DESIGN EXCEPTION #DE44-03

Exception from Access Offset Spacing at 2155 Broadway (Fire Station No. 5)

Redlands Fire Station No. 5

Plan view

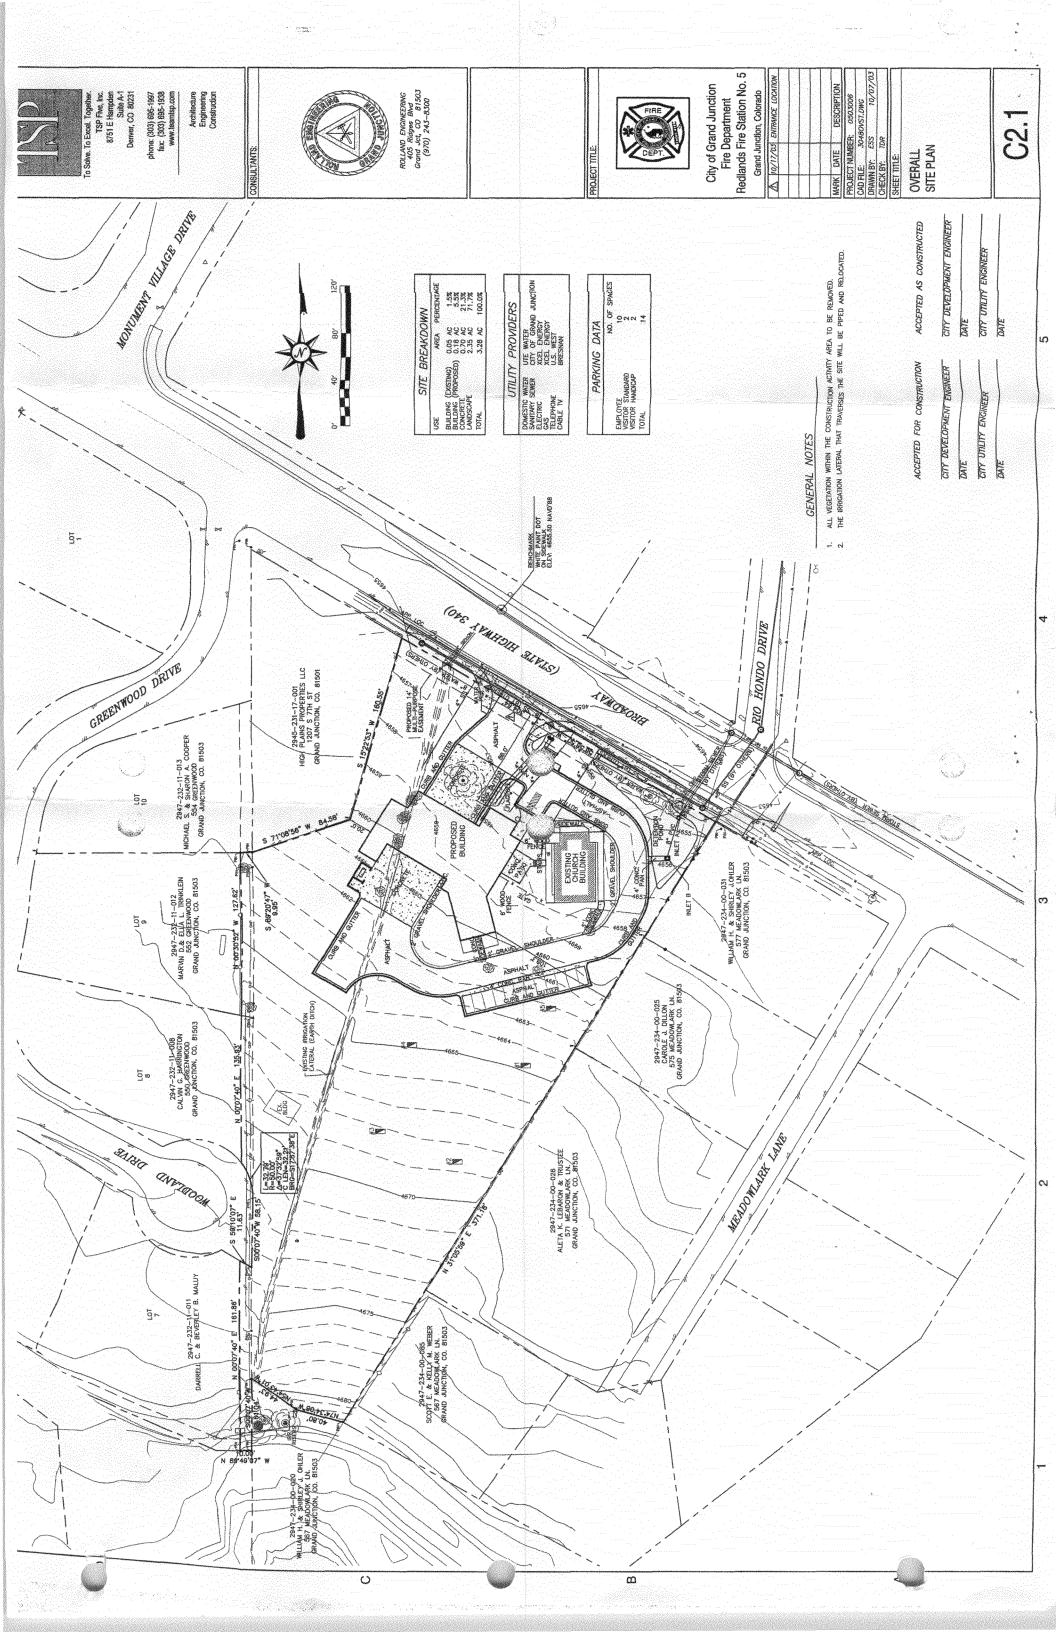
As part of the **Redlands Fire Station No. 5 Improvements**, the existing access will be closed, curb and gutter and sidewalk will be installed along the north frontage of the property along Highway 340 and a new access will be constructed. The distance from the center of the new access to the center of Monument Village Drive is 445 feet. The distance from the center of the new access to the center of Rio Hondo is 145 feet. The offset according to TEDS for an arterial street shall be 300 feet. It is physically impossible to move the access 155 feet to the west because of the frontage

available.

I support Mike's recommendation of approval

I recommend approval of the requested Design Exception to Section 4.1.2, *Offsets*, to allow a 145-foot offset between Rio Hondo Drive and the proposed new Redlands Fire Station access at the above location. I also recommend approval of necessary Design Exception to Section 4.1.2, *Offsets*, regarding the two existing private driveways at 2158 Broadway.
